# WENONA PROJECT ARCHIMEDES

WENONA SCHOOL PTY LTD

## MARK-UP OF SECTION 96 INCLUSIONS

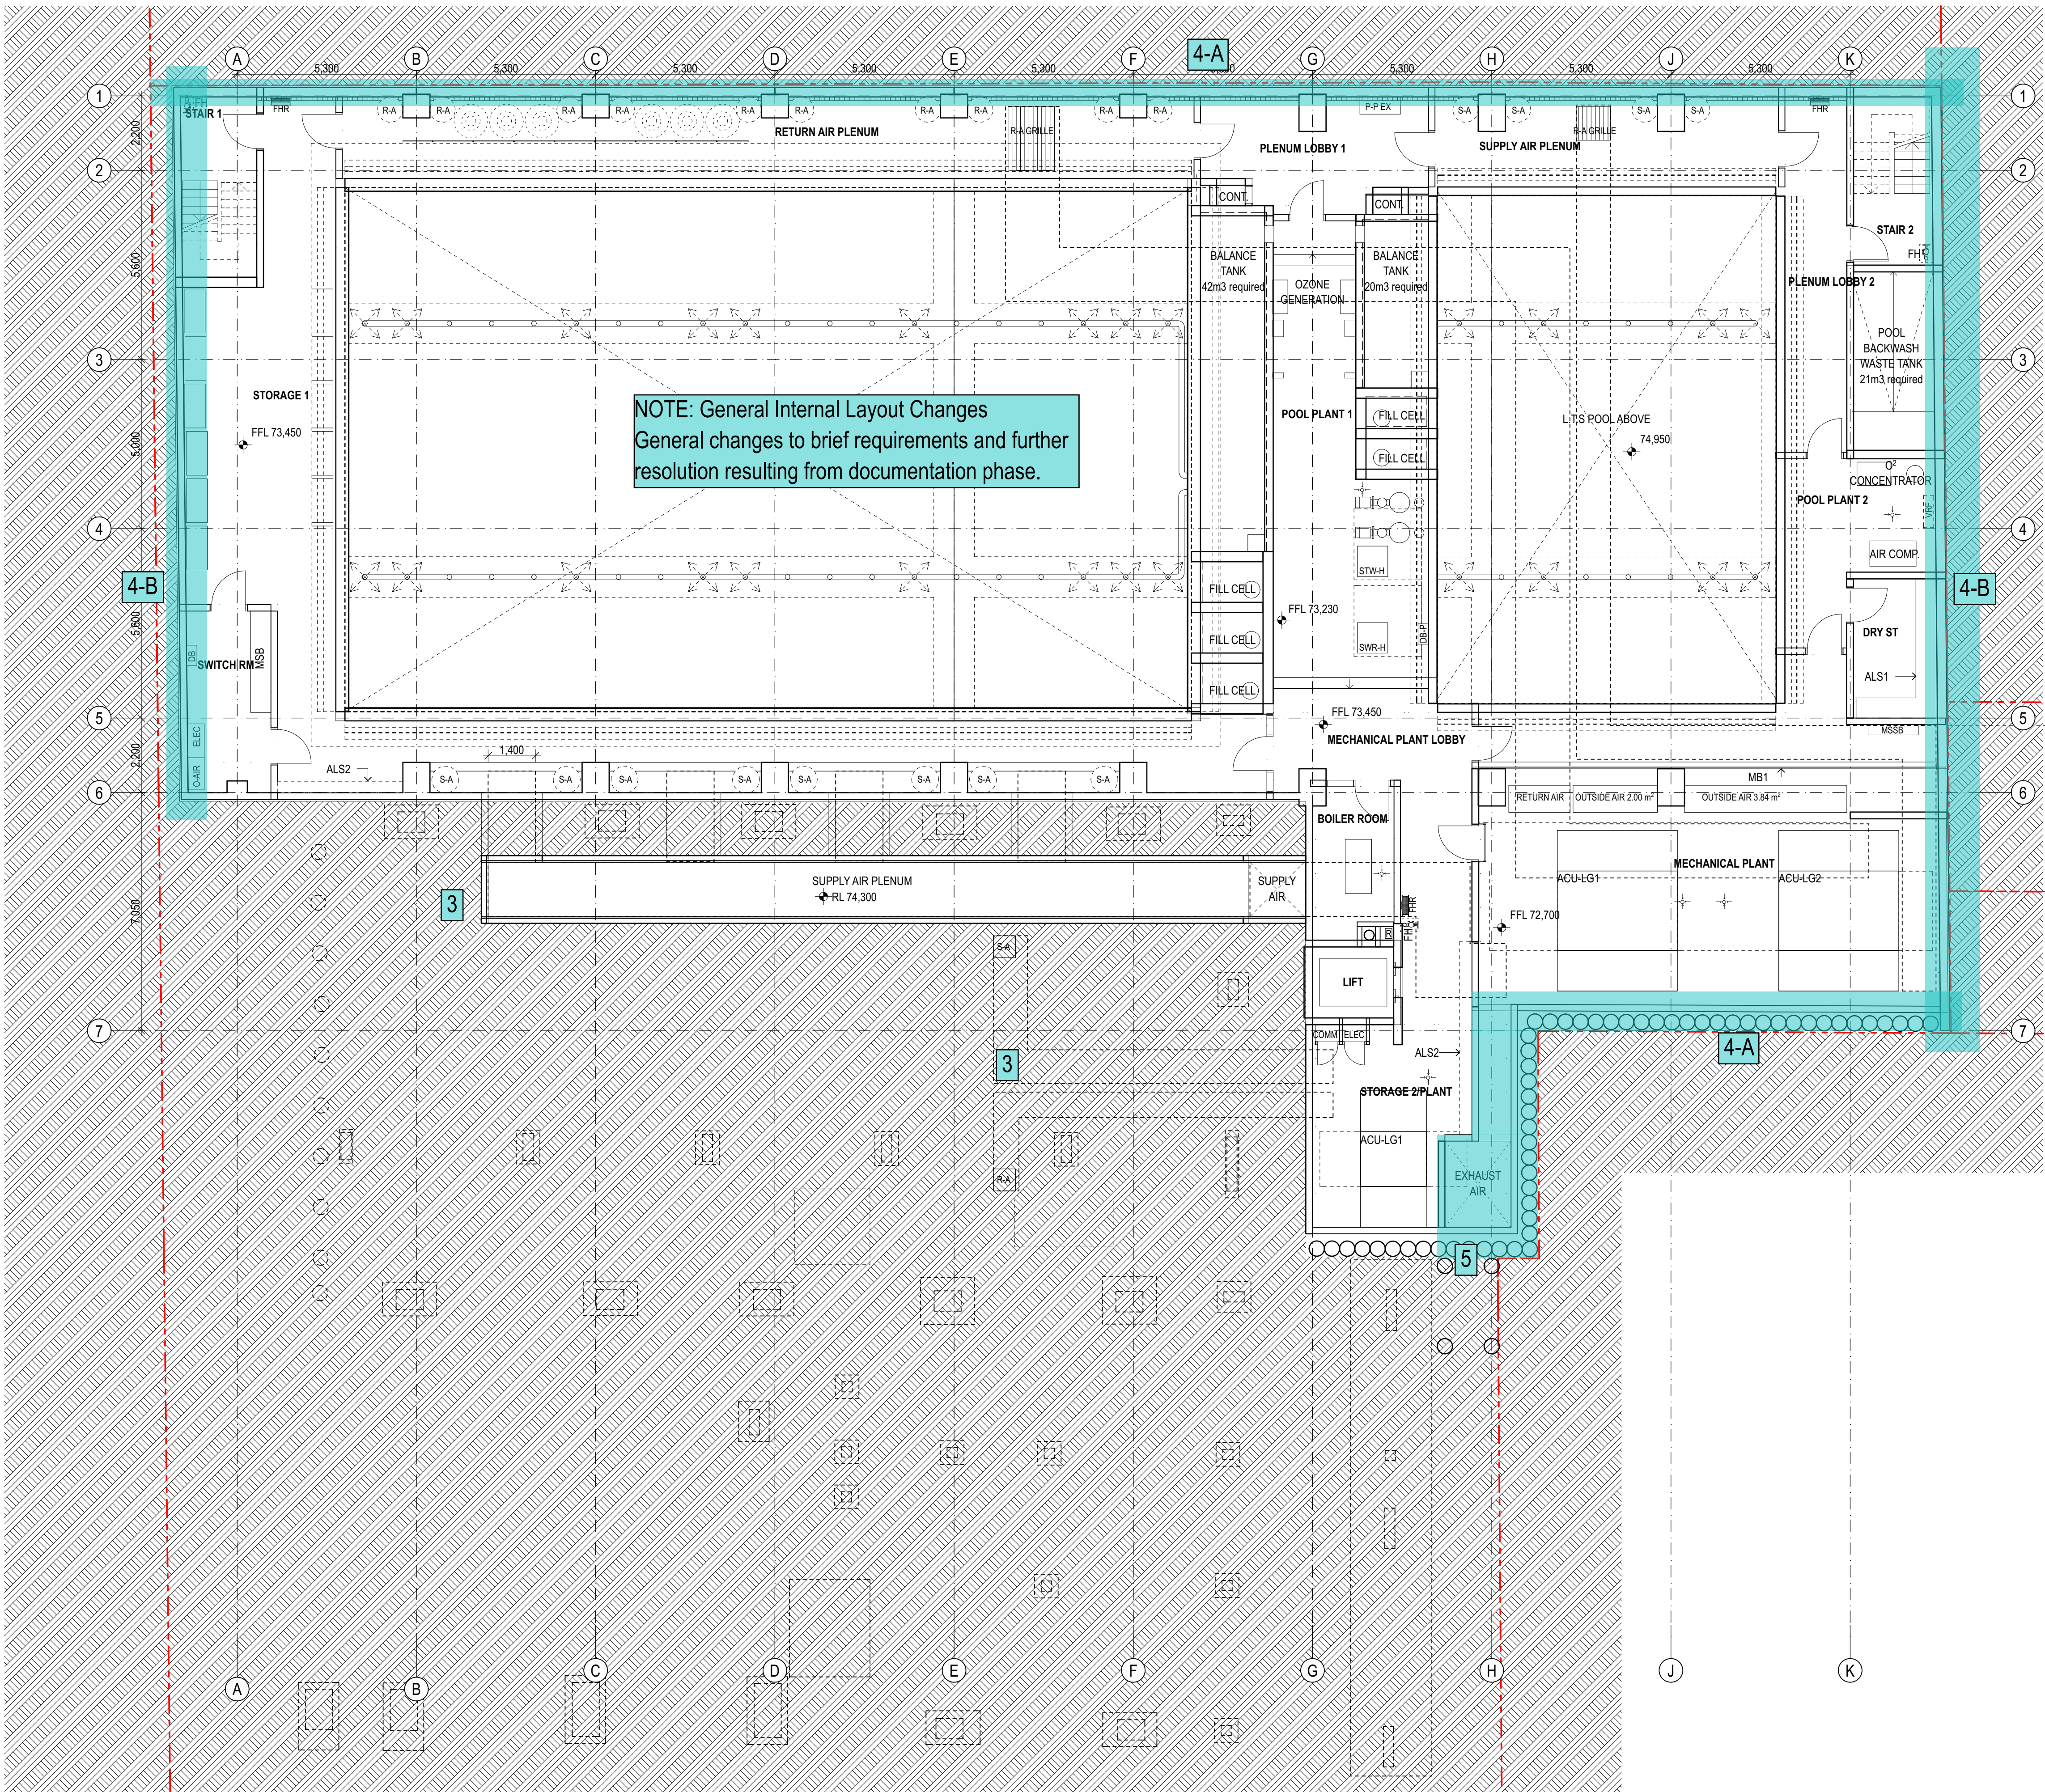
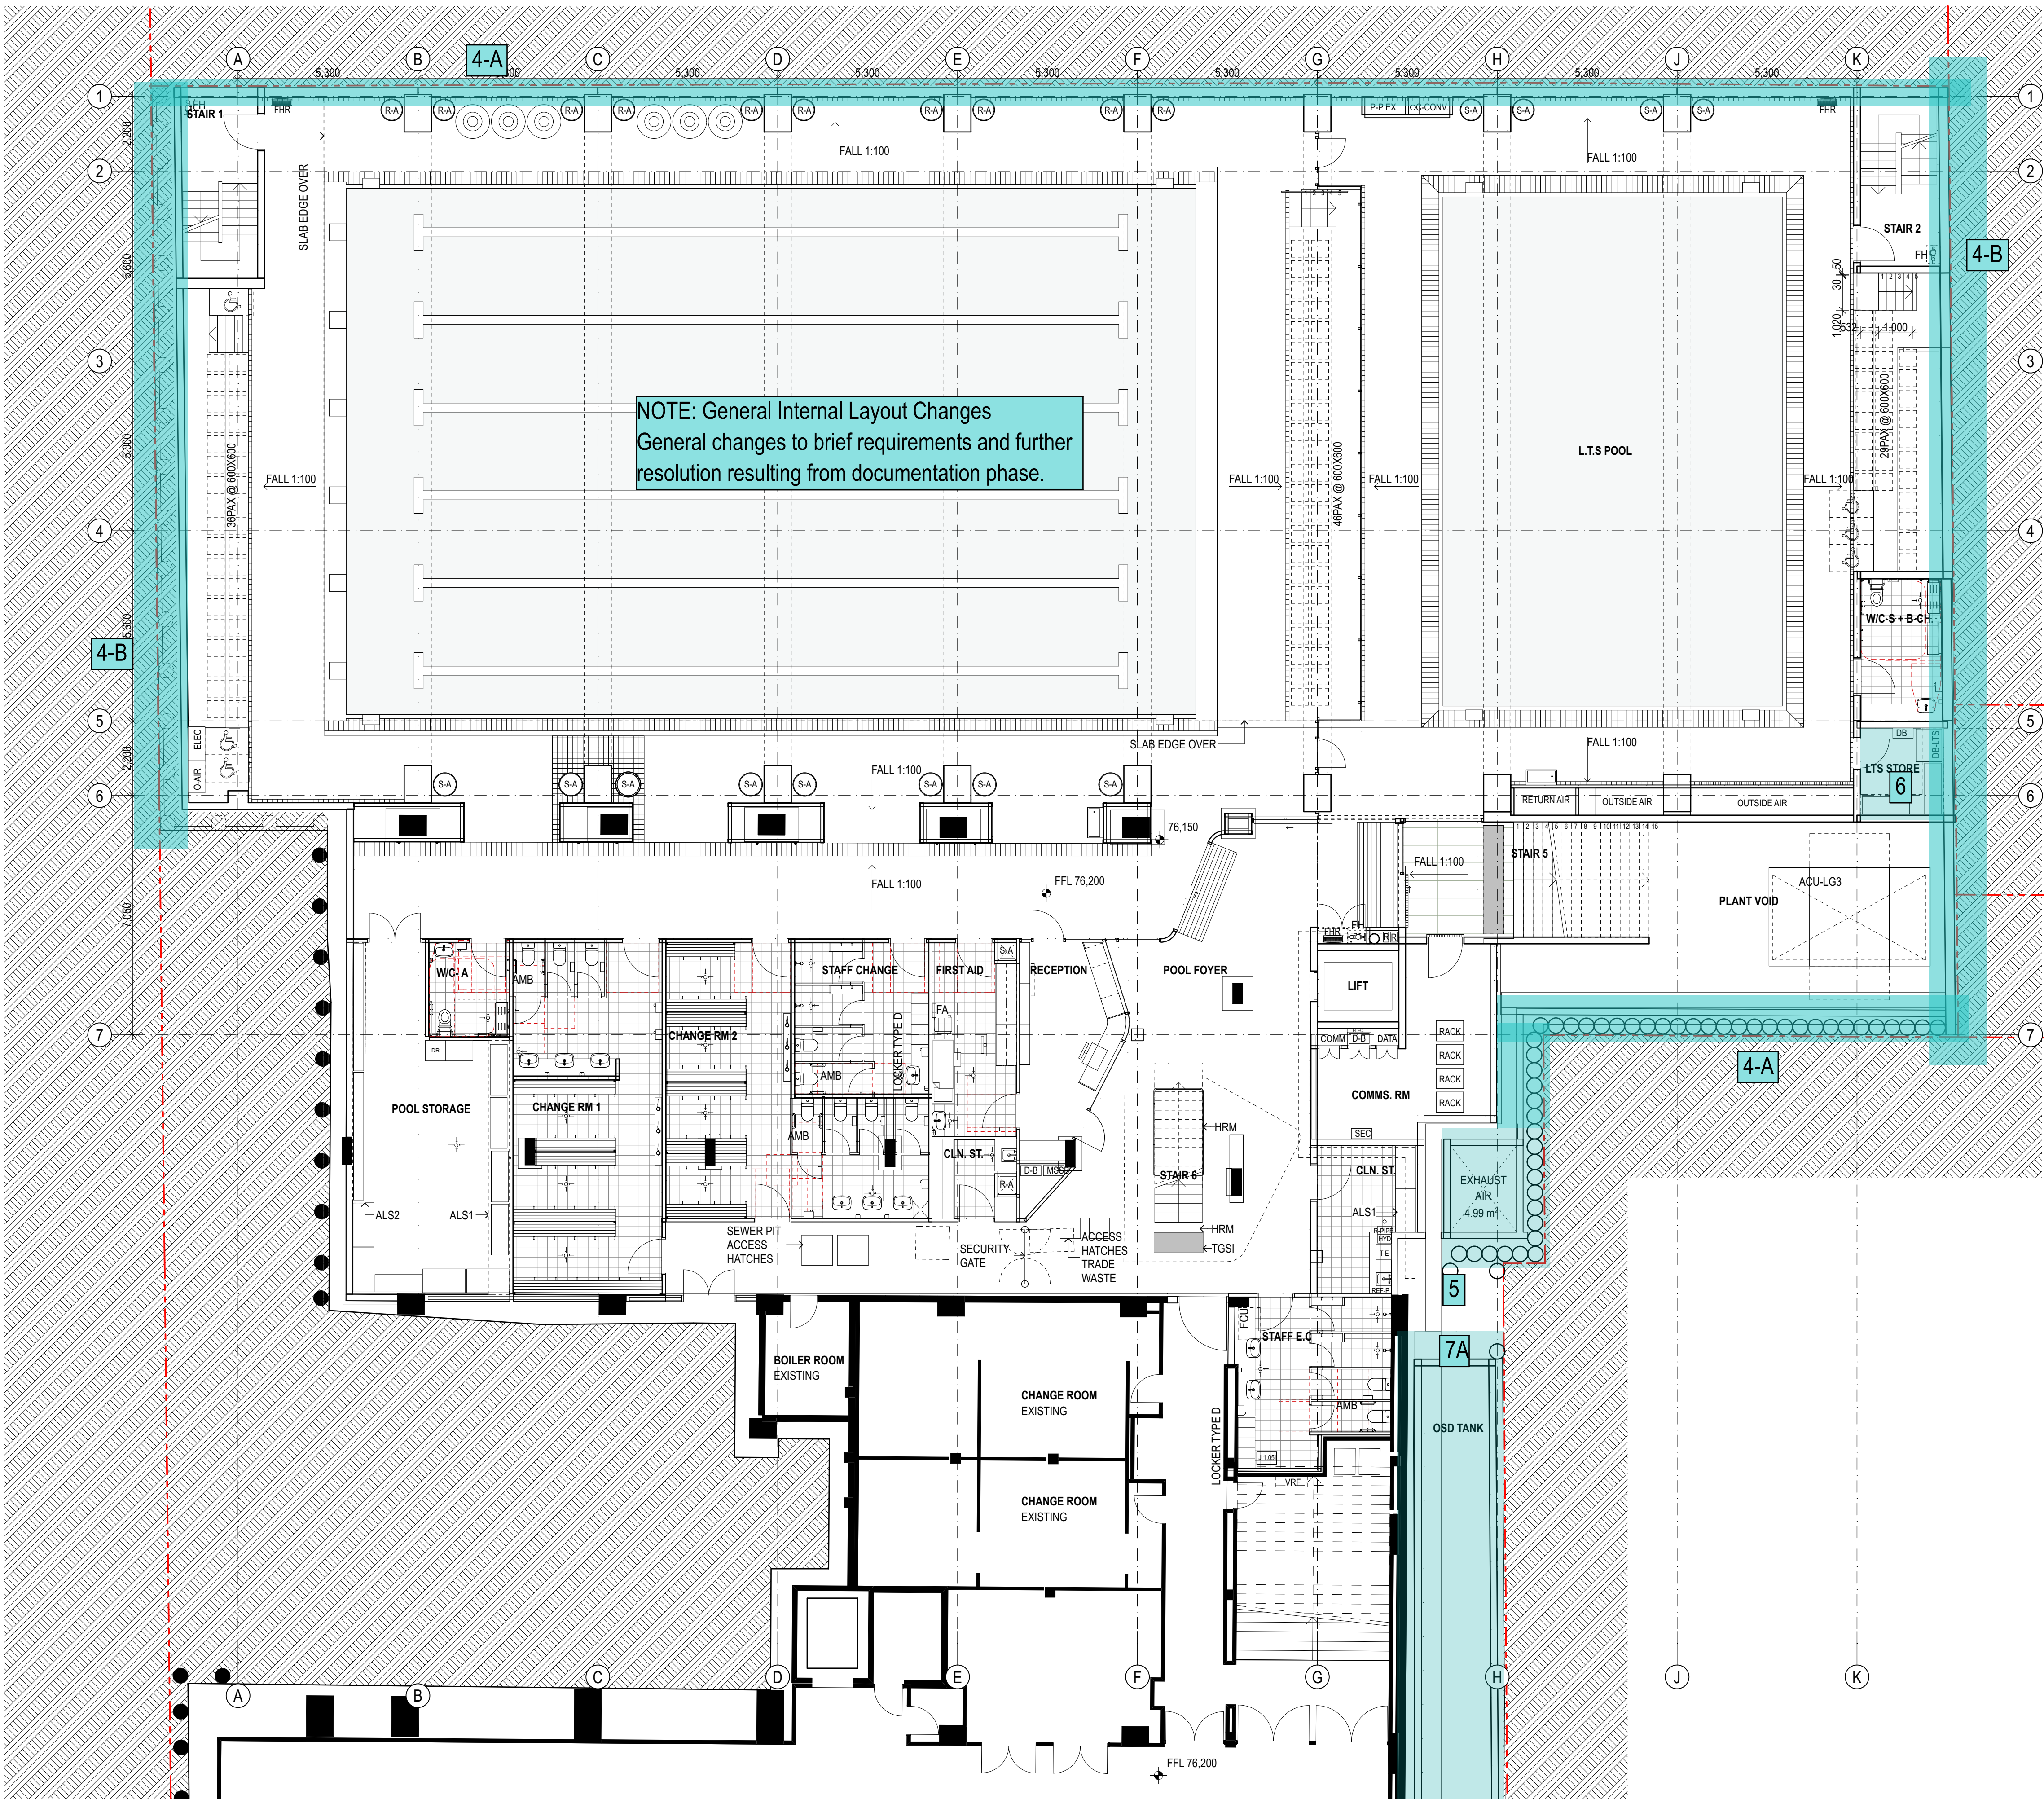
Items requiring S96 approval highlighted below;

- 3** Further Development of Mechanical Trenching has occurred during documentation phase to serve the approved development.
- 4-A** Shoring Design refer to STRUCTURAL + GEOTECHNICAL reports for details

- 4-B** Shoring Design refer to STRUCTURAL + GEOTECHNICAL reports for details
- 5** Exhaust Relocation- The location of the pool exhaust has relocated for design enhancement. The proposed relocation will have a positive effect from the public domain as it will not be visible from Elliott Street.

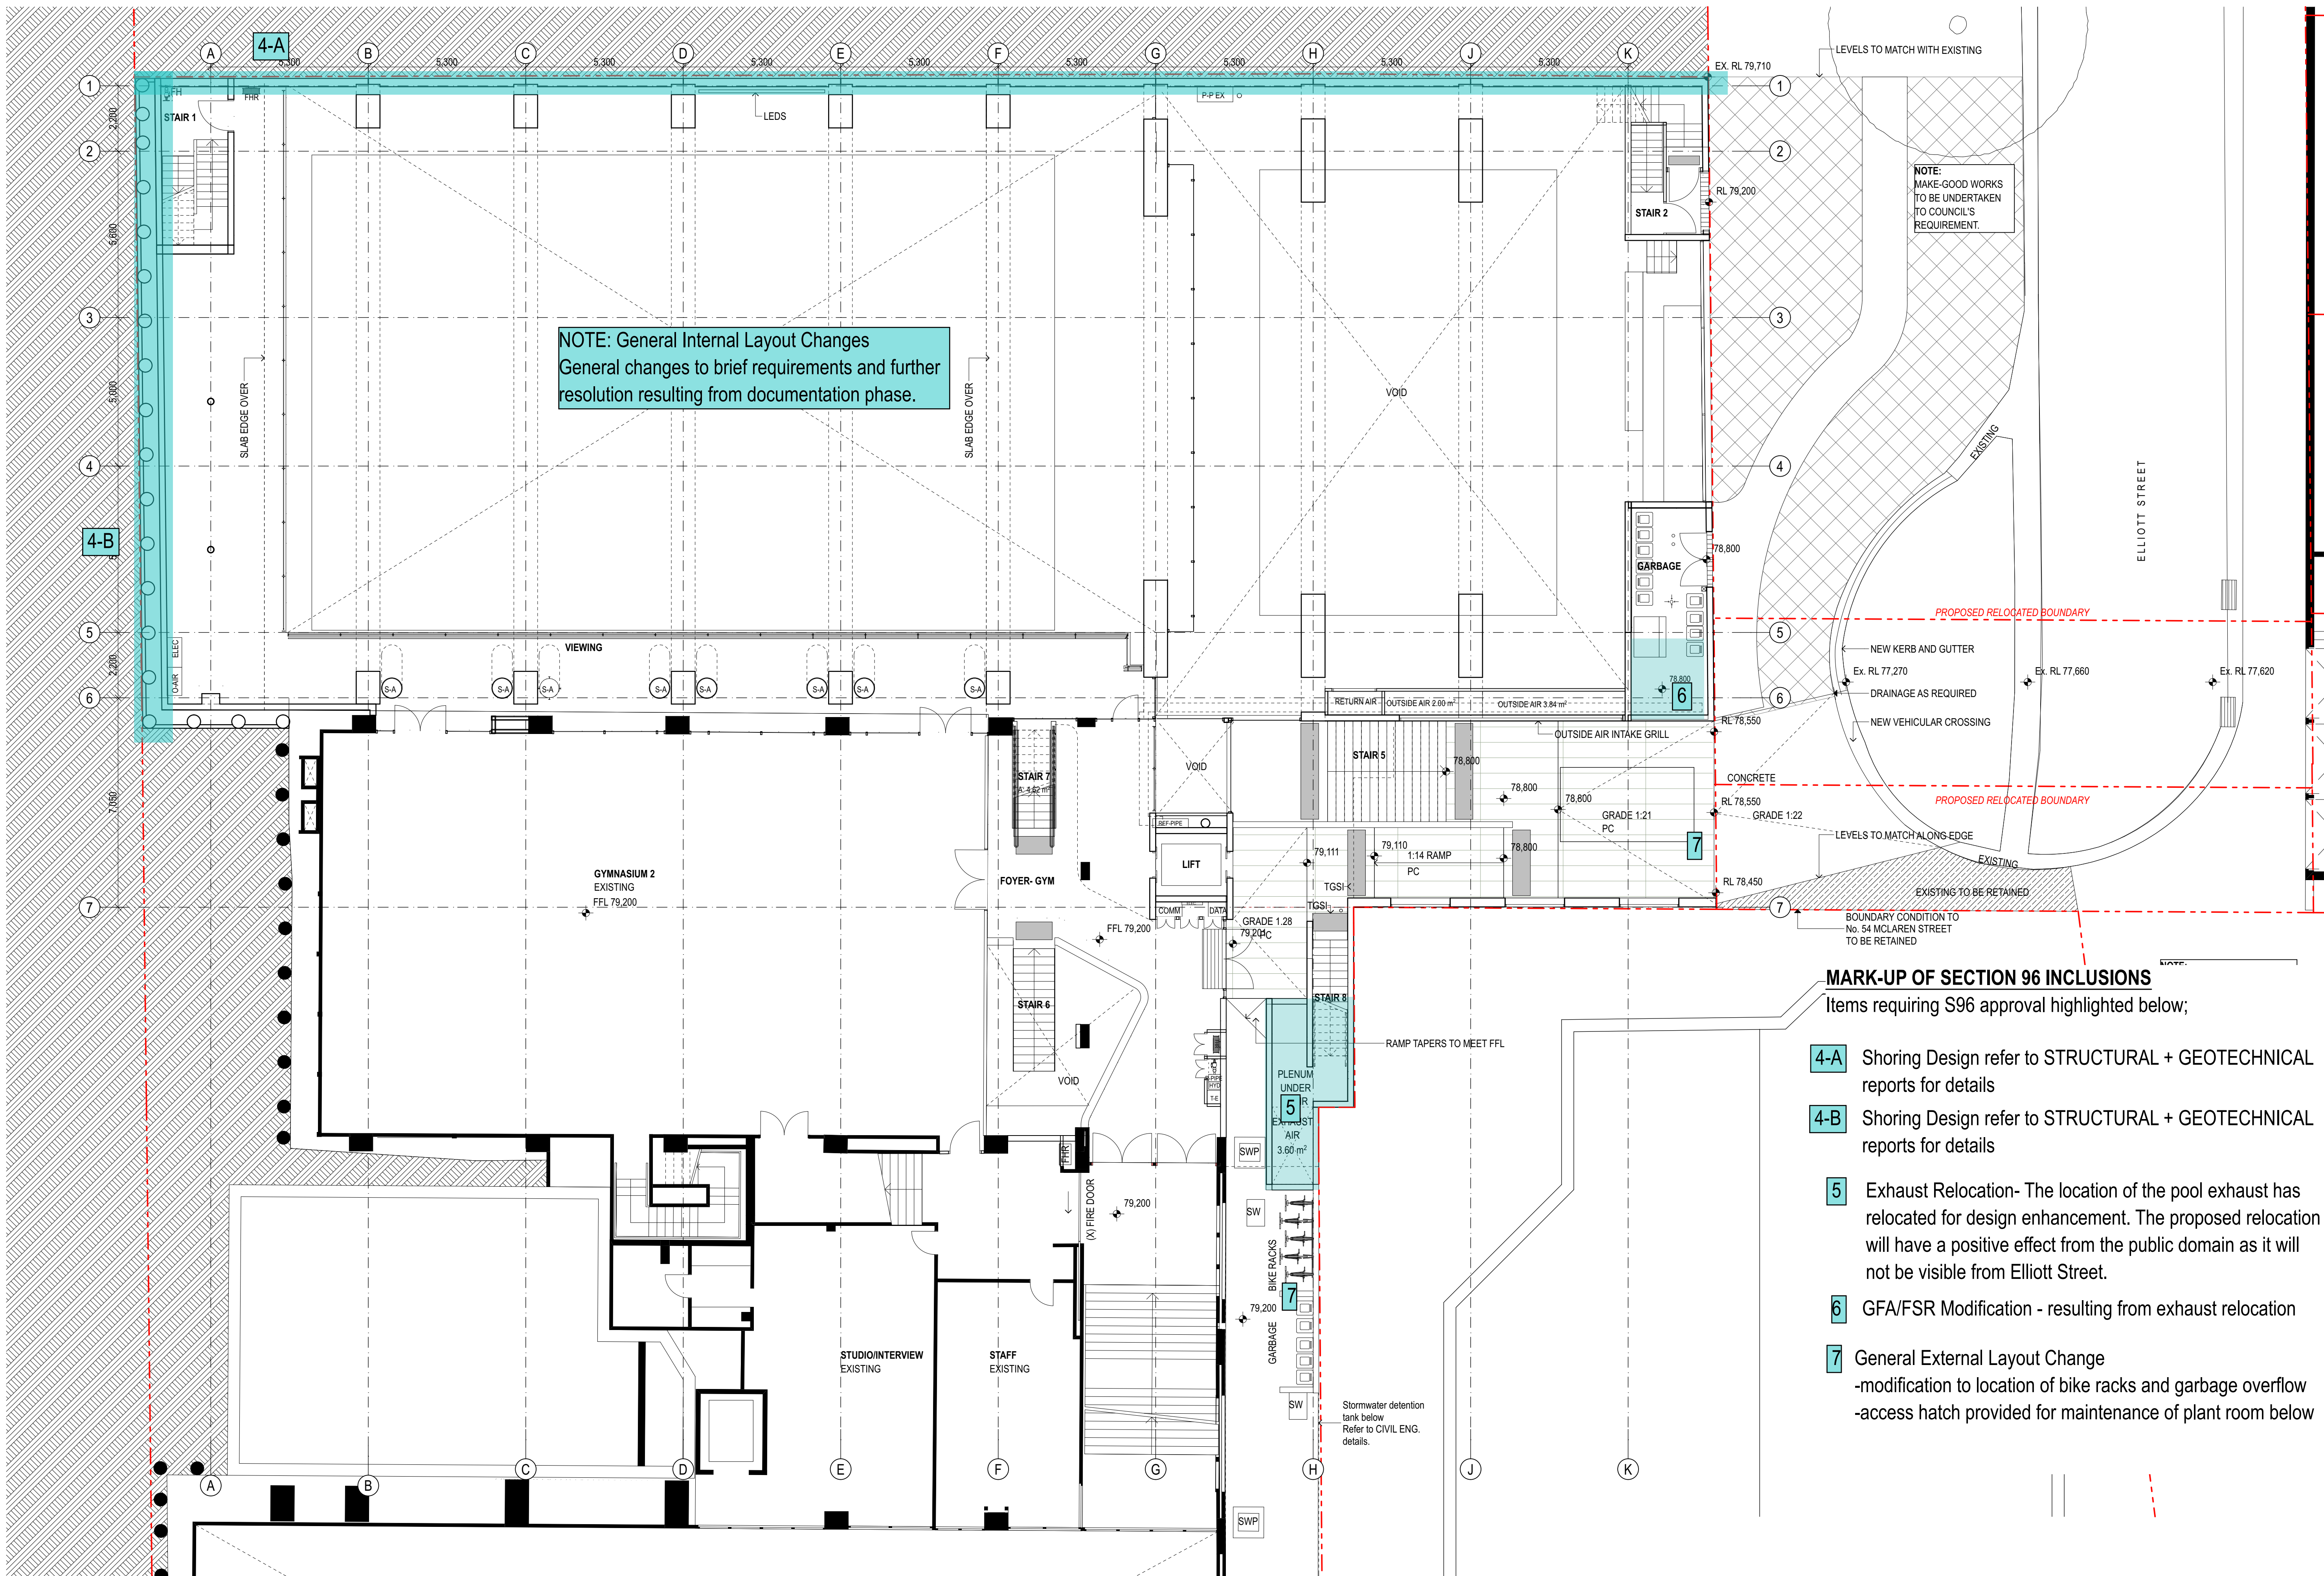
Items requiring S96 approval highlighted below;

- 4-A** Shoring Design refer to STRUCTURAL + GEOTECHNICAL reports for details
- 4-B** Shoring Design refer to STRUCTURAL + GEOTECHNICAL reports for details
- 5** Exhaust Relocation- The location of the pool exhaust has relocated for design enhancement. The proposed relocation will have a positive effect from the public domain as it will not be visible from Elliott Street.
- 6** GFA/FSR Modification - resulting from exhaust relocation
- 7A** Relocation of OSD Tank  
- Relocation from under Elliott Street walkway to below ground, southern end of the site
